Department of Energy
Washington, D.C. 20545
Docket No. 50-537
HQ:S:82:136

REVISED RESPONSES TO 430 SERIES NUCLEAR REGULATORY COMMISSION (NRC)
QUESTIONS

ENCLOSURE

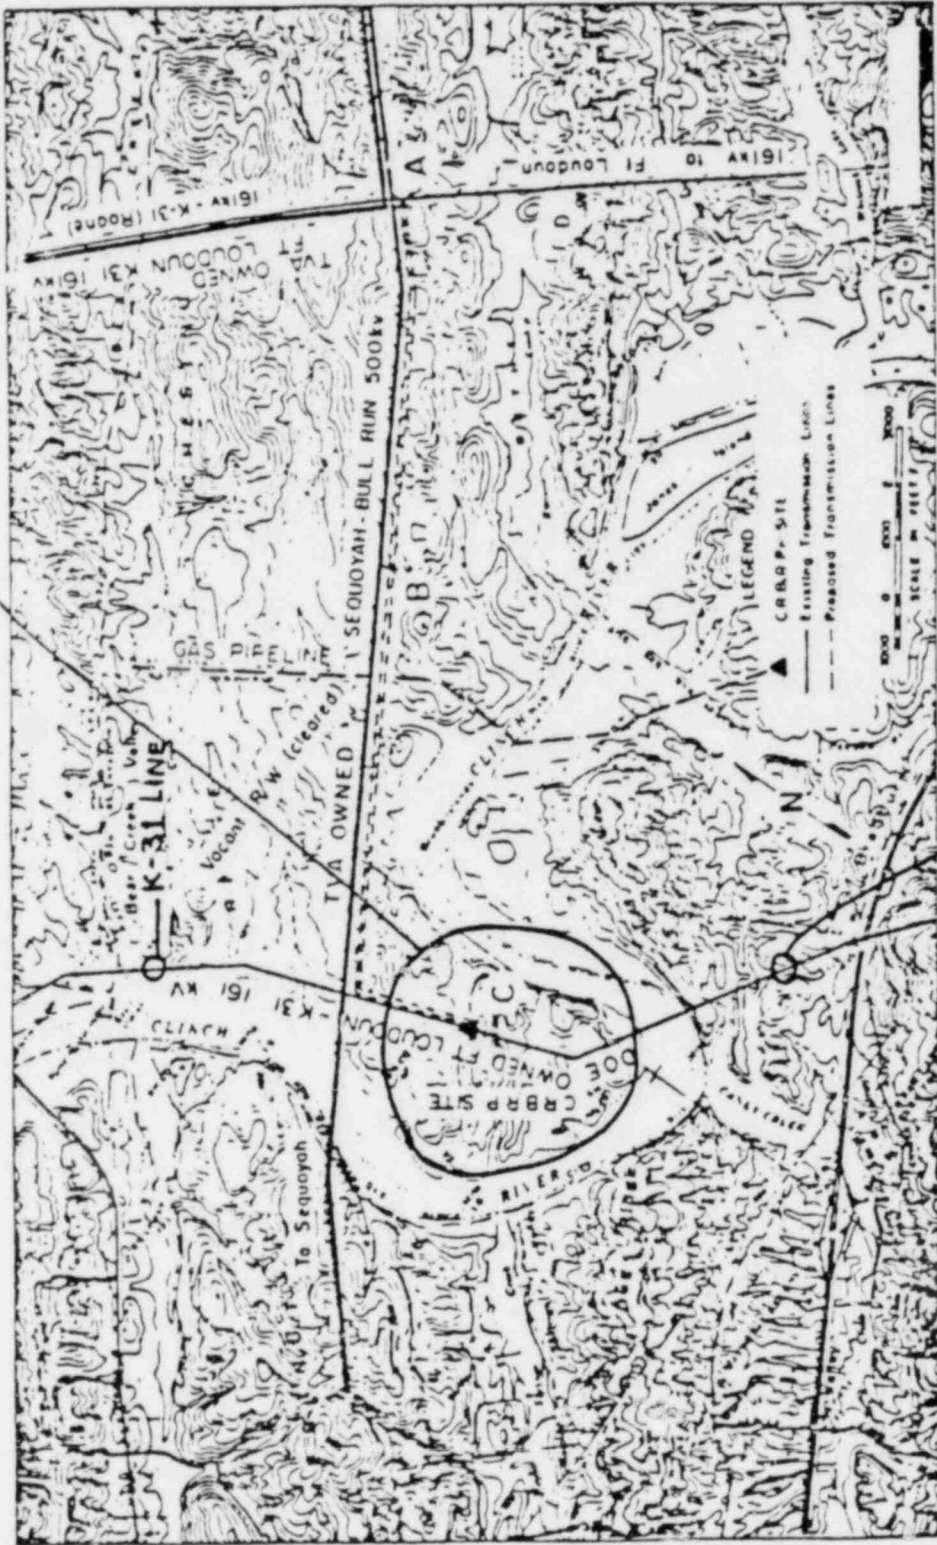
Provide physical layout drawings and/or additional description in the PSAR of the physical independence to be provided between the offsite power circuits in proximity of the plant to the switchyards and from the switchyard to the Class 1E onsite power system. Also provide description of physical independence between Class 1E and the offsite circuits protective relaying.

Control and protection circuits for the Reserve Switchyard have been arranged to receive 125V DC power from two independent Divisions A and B DC power distribution systems (see Figure 8.2-13).

FIGURE 8.3-6 CABLE TRAY SEPARATION

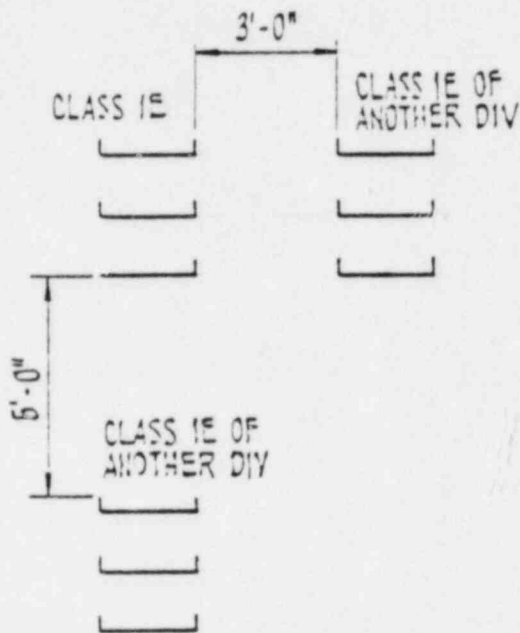
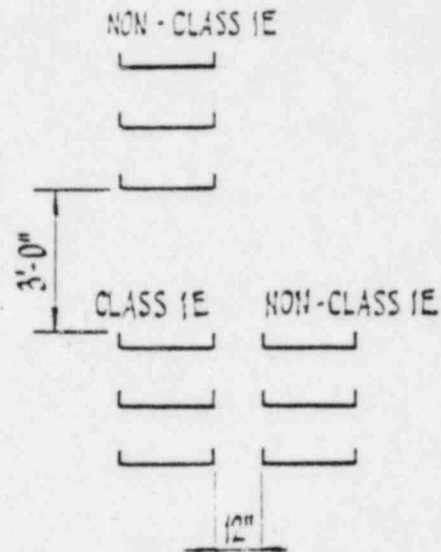
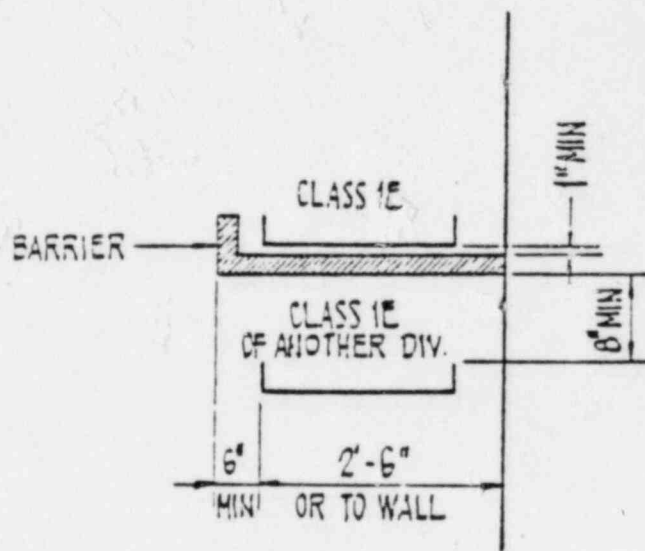
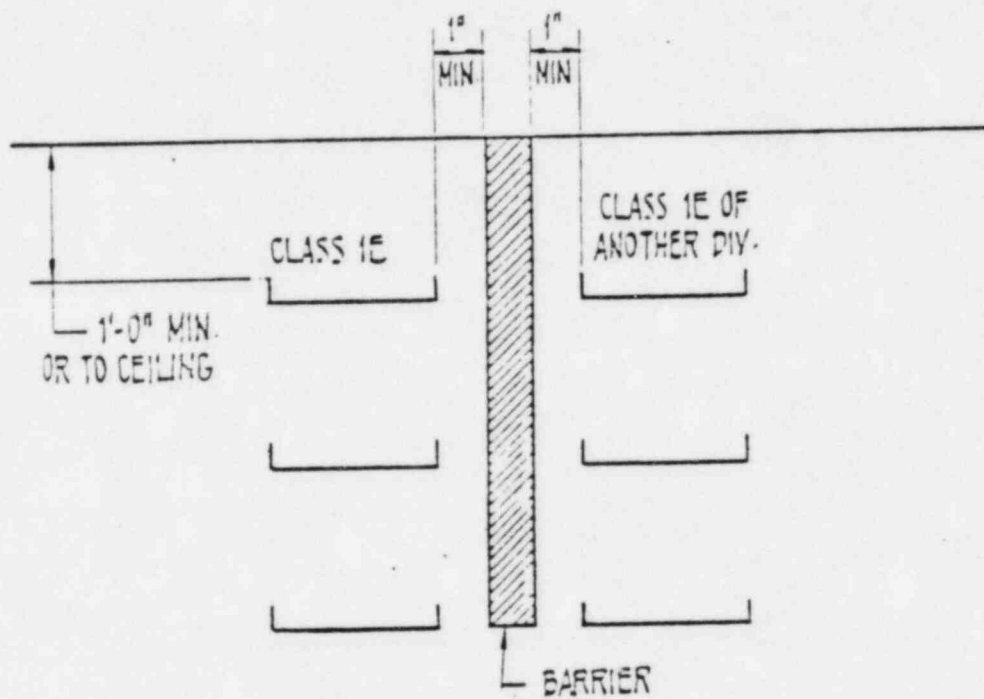
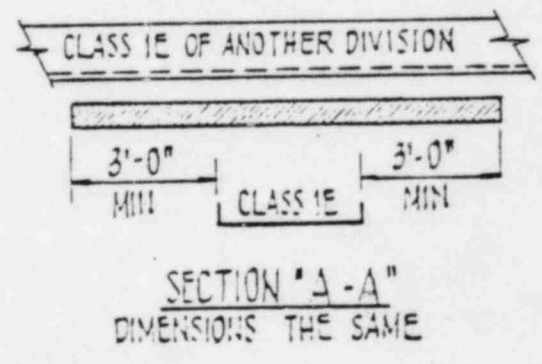
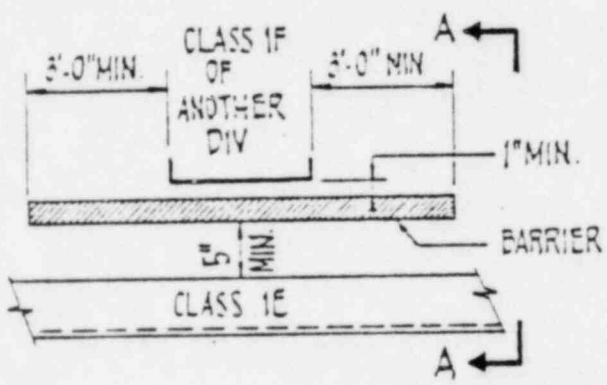
Section 8.3.1.2.14 of the PSAR indicates that physical separation of circuits and equipment comprising or associated with the Class 1E power system, Class 1E protection systems and Class 1E equipment, will be in accordance with criteria set forth in paragraph 8.3.1.4 of the PSAR. Separation criteria described in Sections 8.3.1.2.14 and 8.3.1.4 of the PSAR is not clear and does not meet the guidelines of IEEE Standard 384 and Regulatory Guide 1.75. For example, the PSAR indicates that non-Class 1E cables in panels will be separated from Class 1E cables so that they will not provide a combustion path between different divisions. Section 5.6.5 of IEEE Standard 384-1974 states that non-Class 1E cables shall be separated by six inches or a barrier. In general no criteria has been described for separation of Class 1E and non-Class 1E cables. Other examples include: (1) no criteria for separation between cables trays and conduits of another division, (2) confusing criteria for the separation of the third division (the design indicates there are three divisions but only two redundant divisions. Separation criteria refers to only two redundant divisions in many cases versus the three divisions), (3) confusing definition for associated cables, (4) no criteria for separation between associated cables and non-Class 1E cables, and (5) no criteria before and after an isolation device. Revise your PSAR description of physical separation of circuits to comply with the recommendations of IEEE Standard 384-1974 and guidance of R.G. 1.75 or justify noncompliance.

In Non-Hazard Zones, exposed conduits of different Class 1E divisions are routed as far apart as possible, preferably on opposite sides of the walls. Parallel routing of conduits of different divisions is avoided. If the design makes it unavoidable a minimum of one (1) inch spatial separation is provided between conduits of different Class 1E divisions as shown in Figure 8.3-6. When the safety related conduit cross or run parallel to another safety related tray the minimum horizontal and vertical clearance is the same as provided for cable trays of different Class 1E divisions. If this clearance is unobtainable, a barrier is provided between the safety-related conduits and cable trays of other Class 1E divisions as shown in Figure 8.3-6.

In Non-Hazard Zones, a minimum horizontal clear space of three feet is maintained between cable trays of different divisions as shown in Figure 8.3-6. If a horizontal clearance of less than three feet is unavoidable, a fire barrier is provided between the divisions as shown in Figure 8.3-6.

Vertical stacking of cable trays of different divisions is avoided wherever possible. Where cable trays of different divisions are stacked vertically, a minimum clear space of five feet is provided between the divisions as shown in Figure 8.3-6. If a vertical clearance of less than five feet is unavoidable, a fire barrier is provided between the divisions as shown in Figure 8.3-6.
